3rd January 2017

RE: Blendworth Crescent Lighting

Figure 2. Recommended dark corridor for bats within Mitigation Strategy.

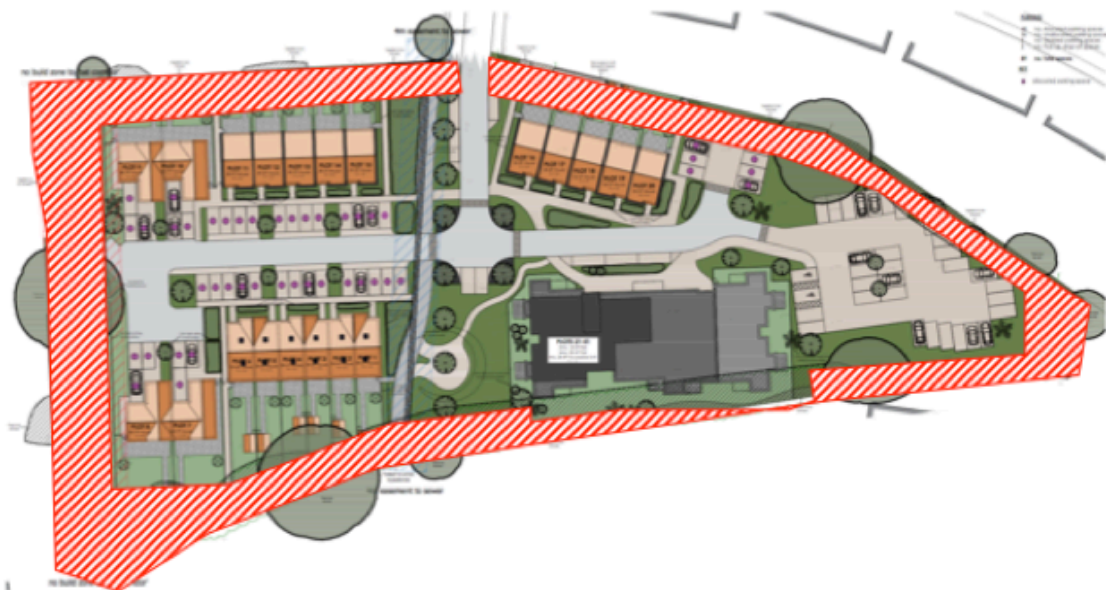
This buffer continues into the eastern section of the site. However here, due to car parking and light levels required for safety reasons, lux levels up to 5 lux will reach the site boundary. This does deviate from the recommended dark corridor outlined within the Mitigation Strategy (please see **Figure 2** below) however as stated within the Mitigation report activity was concentrated within the southeastern corner. As **Figure 1** shows, this extent of the site will remain a dark area. In addition it should be highlighted that the species recorded within this extent of the site were Common and Soprano Pipistrelles (*Pipistrellus pipistrellus* and *pygmaeus*). Pipistrelles are known to be more tolerant to artificial lighting, even utilising such opportunities to increase feeding.

Although the lighting strategy will result in a short stretch of lit boundary vegetation, bats will have the opportunity to utilise the neighbouring gardens, which will remain unchanged. Therefore it is considered unlikely this will result in a severance of commuting routes.
